Item No 09:-

Erection of three dwellings including associated landscaping and other works at Fayrecourt Milton Street Fairford

Full Application 14/04583/FUL (CT.9067)			
Applicant:	Mr Richard Wingfield		
Agent: Pegasus Planning Group			
Case Officer: Claire Baker			
Ward Member(s): Councillor Abagail Beccle			
Committee Date: 8th July 2015

LAND AT FAYRE COURT, FAIRFORD - SITE LAYOUT

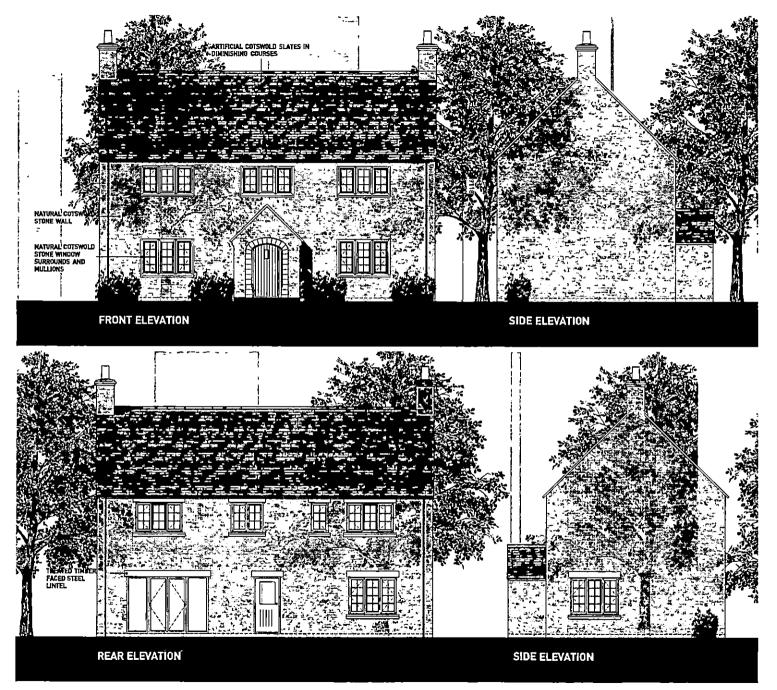
Since objections regarding amenity were received, the proposed plans have been amended and the siting of the houses on plots 2 and 3 have been moved further away from the boundary with 2 and 3 Fayre Gardens. Officers are of the view that there would be no adverse impact on the amenity of these neighbouring properties in terms of overlooking or overshadowing. The closest distance between the rear elevation of 2 Fayre Gardens and the rear elevation of plot 2 is approximately 23 metres and the proposed house would be angled away from of 2 Fayre Gardens. The closest distance between the rear elevation of 3 Fayre Gardens and the rear elevation of plot 3 is approximately 29 metres. Policy 46 does not stipulate acceptable distances between facing elevations but it is generally accepted that a distance of 22 metres between 2 storey facing elevations is an acceptable interface distance. There is also existing boundary vegetation which would help to filter view through to the neighbouring gardens.

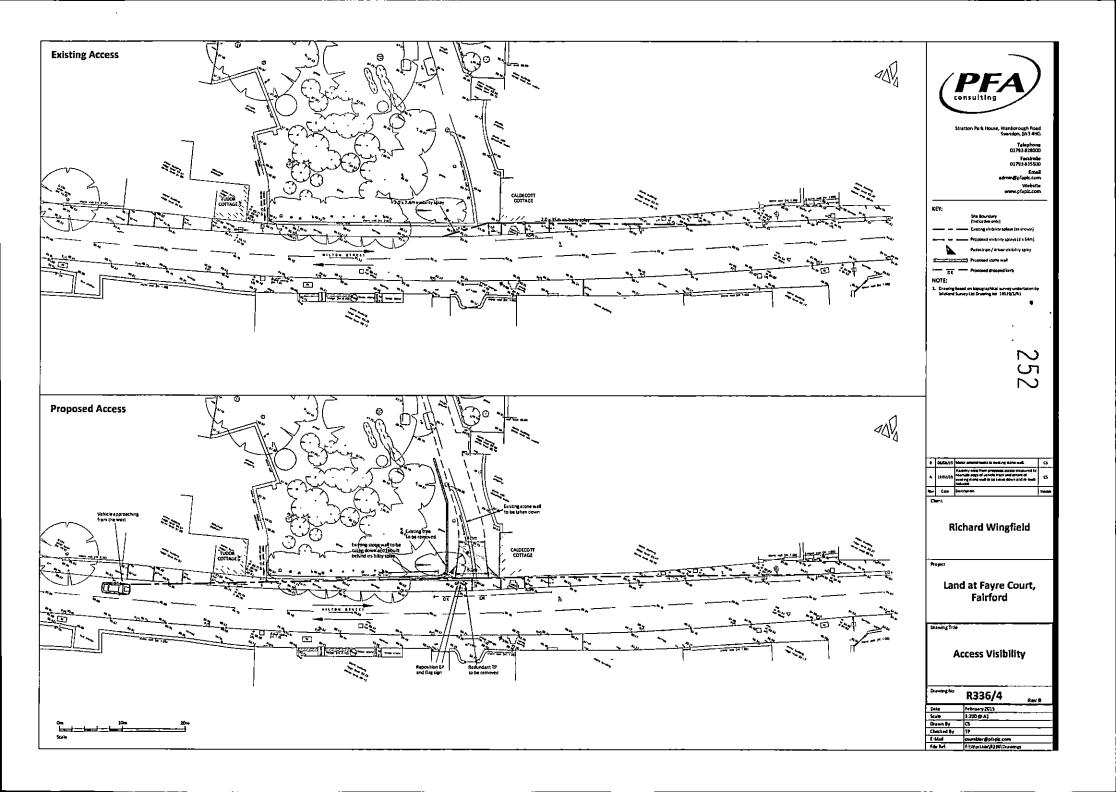
4.1. The proposed site access arrangements will take the form of a re-aligned and widened private driveway. The proposed driveway will have a bound surface and will be a minimum of 4.1 metres in width on the approach to Milton Street (enabling two cars travelling in opposite directions to pass each other). Pedestrian / driver visibility splays will be provided to enable drivers to see pedestrians and pedestrians to see vehicles emerging onto the footway on Milton Road. The existing stone wall fronting Milton Road will be re-aligned and visibility splays of 2.0 x 54 metres will be achieved in both directions in accordance with the visibility splay requirements (see above). To reduce the impact on the stone wall, the visibility splay to the west has been measured to the nearside edge of the vehicle track in accordance with paragraph 10.5.3 of Manual for Streets 2, which states:

4.2. The proposed access arrangements are also shown on PFA Consulting's Drawing Number R336/4 Rev A, which is reproduced at Appendix A.

In order to achieve the visibility splay of 2.0m by 54m improvements are being proposed to the existing access. The existing access is being widened to provide simultaneous access and egress to the site, the widening of the access also provides pedestrian visibility splays which are not currently available, posing a risk to pedestrians on the footway. The existing visibility splays are 2.0m by 35m to the east and 2.0m by 7.4m to the west, the existing 'y' distances are considerably shorter than the required distances and this proposal is an opportunity to improve them to the required distances. In addition the existing loose gravel surface will be replaced with a bound surface that will not spill onto the highway causing inconvenience and safety concerns for highway users.
